Subject: Preliminary Draft of Proposed Monitoring Program

PRELIMINARY DRAFT
Framework for Monitoring Program
at the
Triassic Park Facility

TRIASSIC PARK WASTE DISPOSAL FACILITY

Comments regarding the Proposed Monitoring Program (annotated and abbreviated due to lack of time)
This should not be construed to constitute all additional needs of the monitoring program.

TYPICAL VADOSE ZONE MONITORING WELL INSTALLATION DETAIL

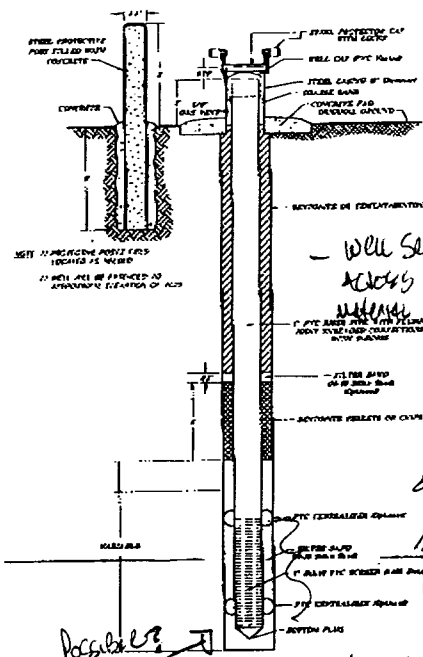
- Too difficult to install angle holes & muds
- I want vertical boreholes.
- Proposed locations may not monitor entire facility.
- MAY need extra wells.

10' W/O LOWER DRAIN 5' SLOT BELOW CONTACT.

may NOT extend screen length to near surface?

- Need wells 10 feet into Lower Dockum
- Need assurance during well drilling of depth of contact
- Need 5 foot sump at bottom of well and screen interval to span the contact.
- Need commitment to construct wells with appropriate materials.
- Need wells sealed across contact of alluvial material and Upper Dockum.
